# PERMIT

SEWAGE DISPOSAL SYSTEM

MARYLAND STATE DEPARTMENT OF HEALTH

SUBDIVISION \_\_\_\_\_ ROAD 10834 Braeburn Road LOT 21

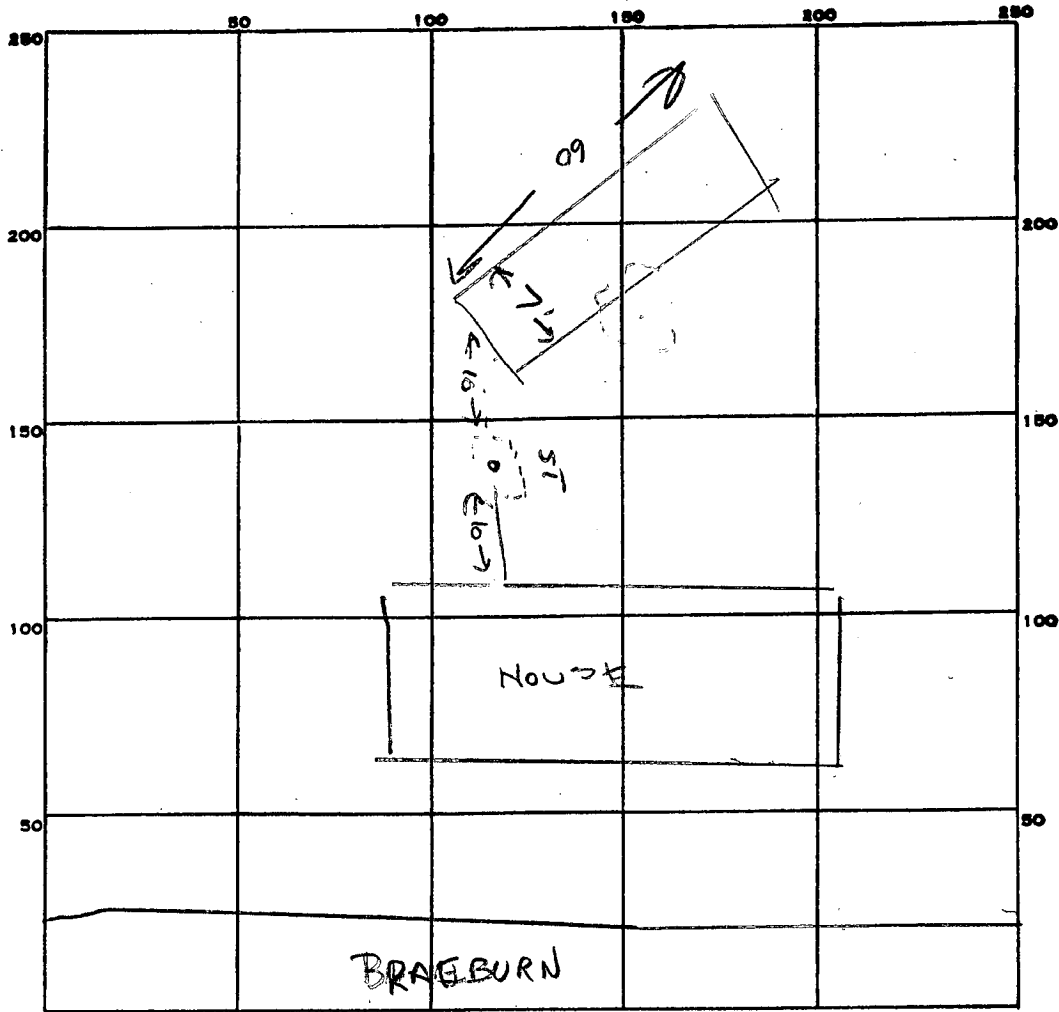
REPAIR - CALL FOR INSPECTION WHEN GROUND IS OPENED UP SO SANITARIAN CAN RECOMMEND REPAIR.

SOIL SAND LOAM - WATER AT 12'  
INSTALL LEACHING BED 7' X 60' = 420 SQ FT, 11-3-83 C. Walker

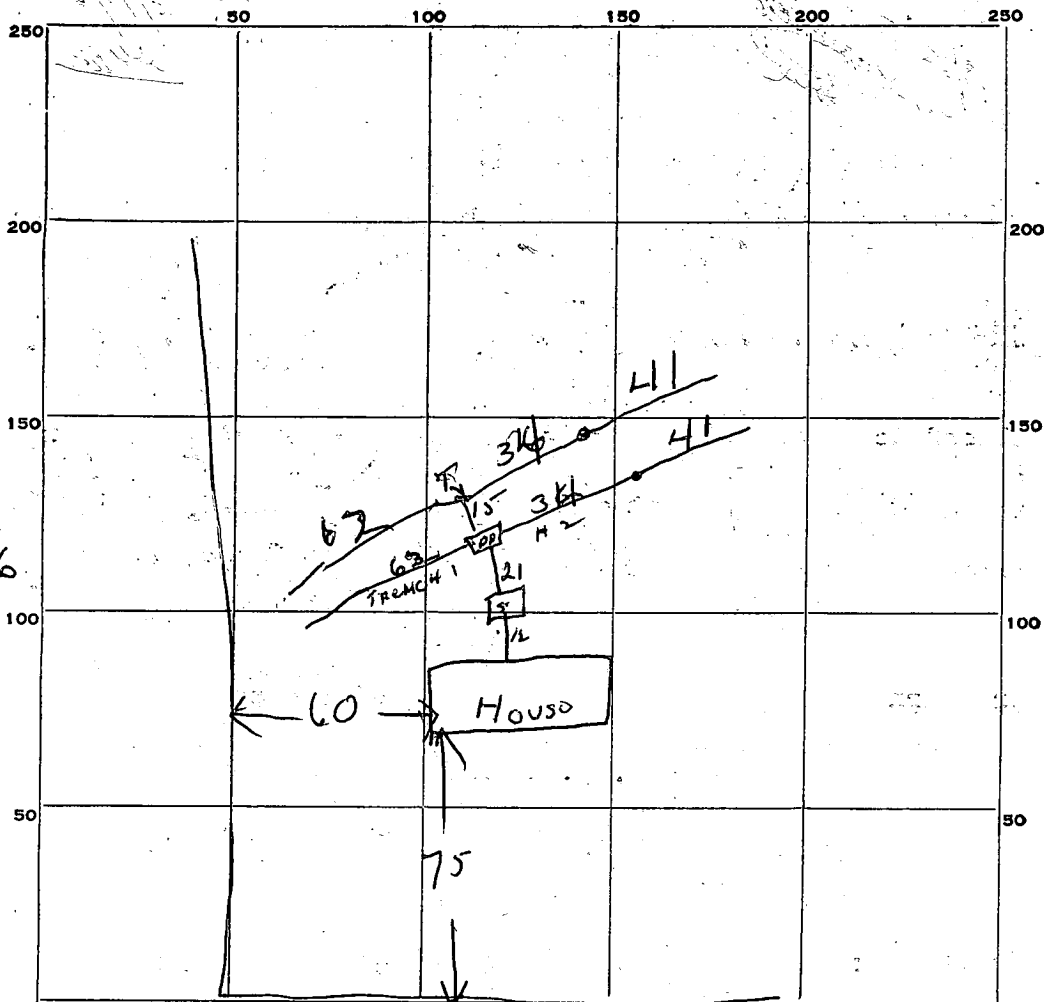
REMARKS 8/13/63 - system needs additional <sup>224</sup> sq ft trench area. area trenches not connected separately to dist. box. Location of trenches need to be checked.

OTHER place field 110 to 175 ft. from front lot line and 25 to 180 ft. from left side of lot as seen when facing lot from Braeburn Dr.

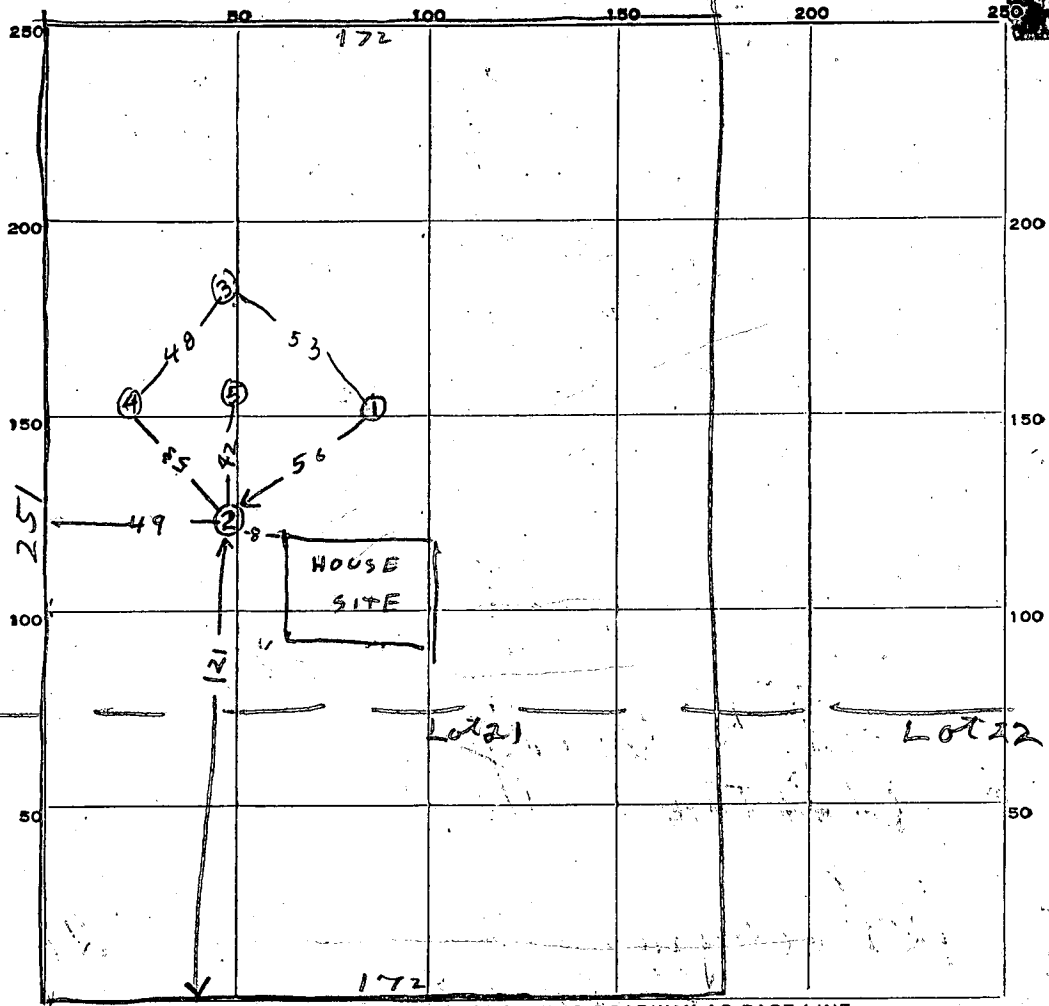
*27 MAR 63 Possibility of*

*Underground water in 8 FT hole*

DATE	TEST NO.	DEPTH	PRE-WET		TEST - 1" DROP		TIME	
			START	STOP	START	STOP		
3-27-63	1	4	1 10	1 20	1 20	1 28	8 min	
" "	2	4	1 14	1 42	1 42	2 06	24	
" "	3	4	1 15	1 18	1 18	1 17	1	
" "	4	4	1 22	2 10	little perc			
" "	5	4	1 29	2 10	little perc			
" "	6	7	WATER UP TO		6 FT LEVEL. COULD			
			BE EITHER RAIN WATER, OR UNDERGROUND WATER

*Place the tide field in the area 110 ft to 175 ft from the front lot line and 25 ft to 100 ft from the left side of the lot as shown when facing the lot from Braeburn Drive*
